## CHART STANDARDIZATION & PAPER CHART WORKING GROUP (CSPCWG)

### CSPCWG Letter: 08/2013

**Subject: Actions from 9<sup>th</sup> CSPCWG meeting: Group 1 'Clarifications'  
Follow-up to Letter 04/2013.**

**CSPCWG9 Actions drafts: Group 1 'Clarifications'**

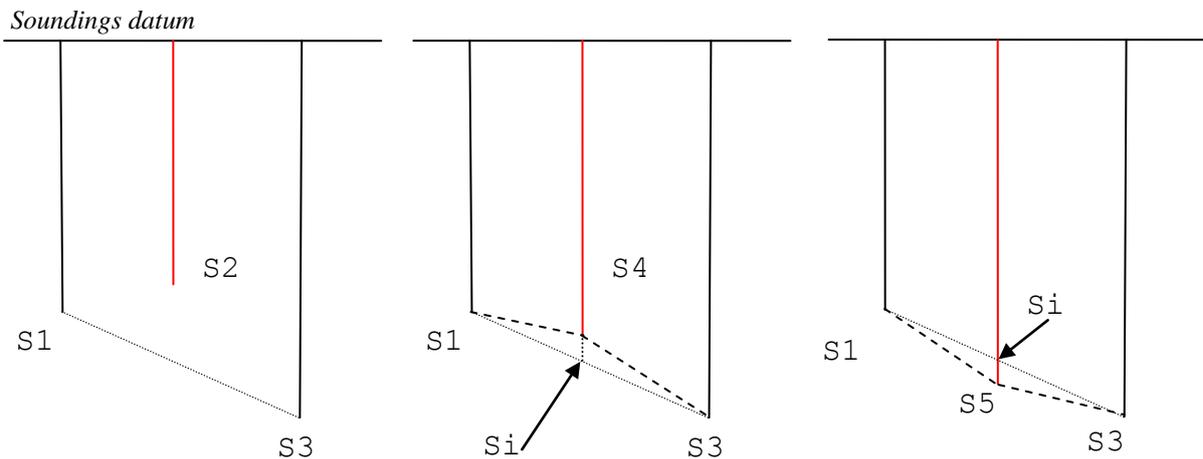
Action 41 / B-410a:

The proposed rules are not sufficient and cannot be applied as they are written. With the proposed rules, we can have depths which are not safe. The three schemes below show:

- On the left side, if S1 and S3 are the two charted soundings, following the application of the proposed rule, the sounding S2 can not exist between the two charted soundings S1 and S3, because S2 is less than S1 which is the lesser of the two charted depths; *I agree with that.*

- On the middle, if S1 and S3 are the two charted soundings, following the application of the proposed rule, the sounding S4 can exist between the two charted soundings S1 and S3, because S4 is not less than S1 which is the lesser of the two charted depths; but S4 is not a safe depth, S4 must be less than the interpolated\* depth  $S_i$  calculated with S1 and S3.

- On the right side, if S1 and S3 are the two charted soundings, the sounding S5 can exist between the two charted soundings S1 and S3, first, because S5 is not less than S1 which is the lesser of the two charted depths (proposed rule), second, because S5 is less than the interpolated\* depth  $S_i$  calculated with S1 and S3.

\* Linear interpolation; for the use of this rule for the validation of soundings within the triangle of charted soundings, no actual sounding will exist above the plan defined by the triangle.

The first rule could be modified as follow: no actual sounding will exist within a triangle of charted soundings which is less than the interpolated depth calculated at its position with the soundings defining the edges of the triangle; and

the second rule could be modified as follow: no actual sounding will exist between two adjacent charted soundings forming an edge of the triangle which is less than the interpolated depth calculated at its position with the two charted soundings.

**Chairman:** because the seabed does not shoal evenly, exact interpolation can never be achieved. The expectation of the mariner is that a sounding will be somewhere between S1 and S3 but not exactly proportional to the distance from each. I believe the last sentence of proposed B-410a adequately covers the issue.
